Z10.4 Hull Surveys of Double Hull Oil Tankers

(Dec.
2001)
(Rev. 1
Oct. 2002)
(Rev.2
June
2005)
(Rev.3
Jan 2006)
(Rev.4
June 2006)
(Corr.1
Sept 2006)
(Rev.5
Feb 2007)
(Rev.6
Nov 2007)
(Rev.7
Mar 2009)
(Rev.8
Feb 2010)
(Rev.9
Mar 2011)

Figure 1 - Pitting intensity diagrams

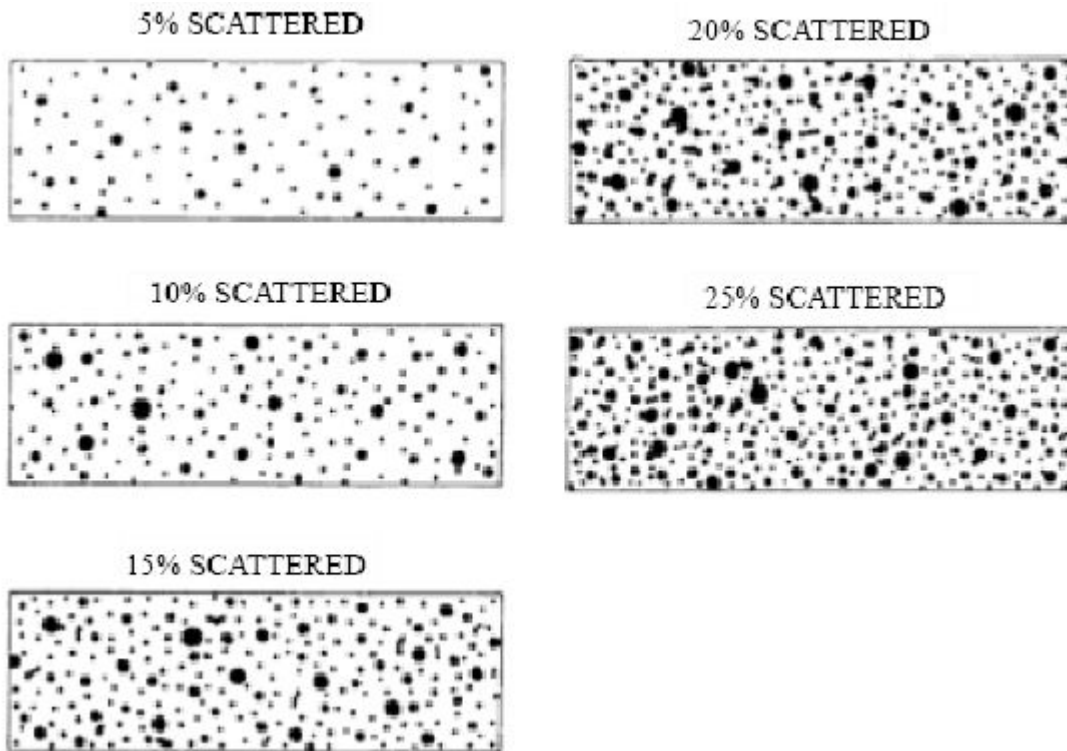
Pitting corrosion is defined as scattered corrosion spots/areas with local material reductions which are greater than the general corrosion in the surrounding area. Pitting intensity is defined in Figure 1.

8.2.1 For plates with pitting intensity less than 20%, see Figure 1, the measured thickness, t_m , of any individual measurement is to meet the lesser of the following criteria:

Figure 2 - Edge corrosion

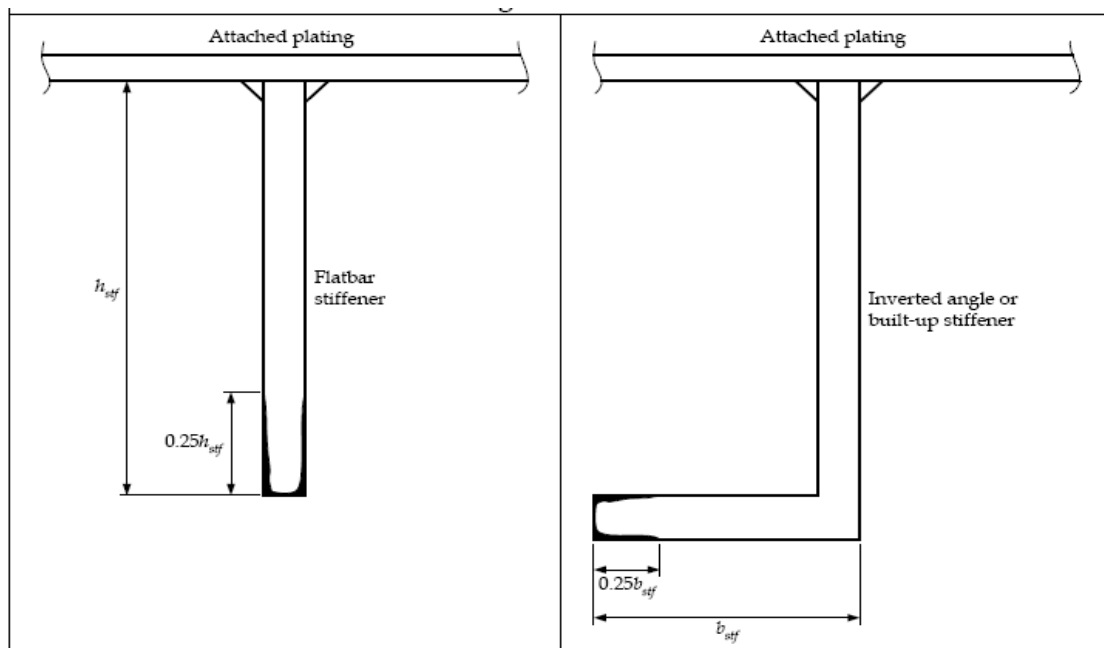
Edge corrosion is defined as local corrosion at the free edges of plates, stiffeners, primary support members and around openings. An example of edge corrosion is shown in Figure 2.

8.3.1 Provided that the overall corroded height of the edge corrosion of the flange, or web in the case of flat bar stiffeners, is less than 25%, see Figure 2, of the stiffener flange breadth or web height, as applicable, the measured thickness, t_m , is to meet the lesser of the following criteria:

Figure 3 - Grooving corrosion

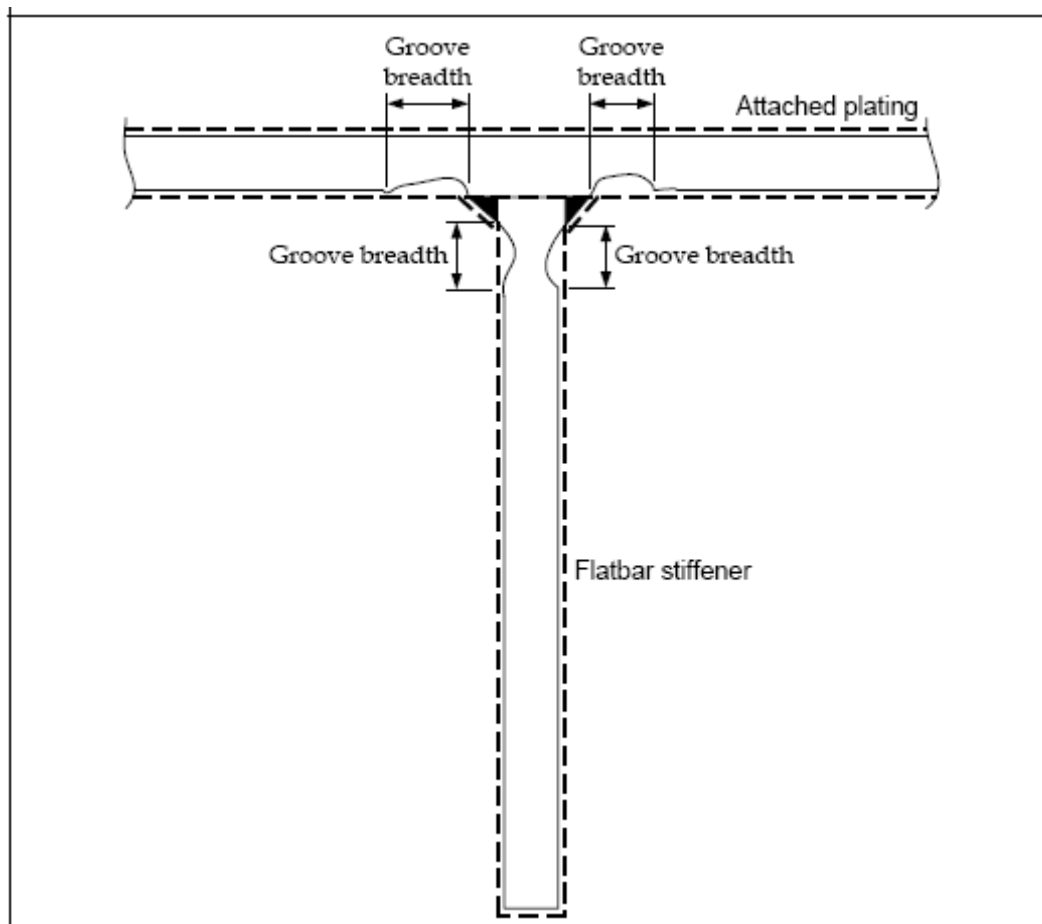
Grooving corrosion is typically local material loss adjacent to weld joints along abutting stiffeners and at stiffener or plate butts or seams. An example of groove corrosion is shown in Figure 3.

8.4.1 Where the groove breadth is a maximum of 15% of the web height, but not more than 30mm, see Figure 3, the measured thickness, t_m , in the grooved area is to meet the lesser of the following criteria:

Figure 4

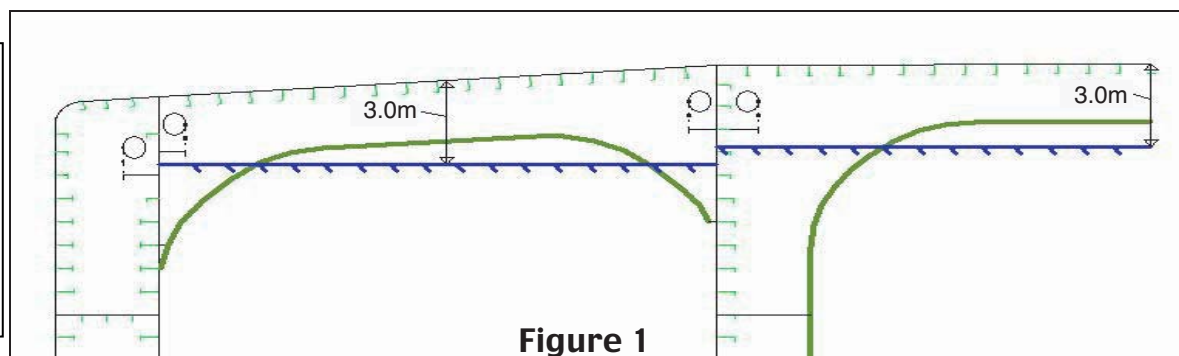
Delete text

Figure 4
re-numbered
to
Figure 4
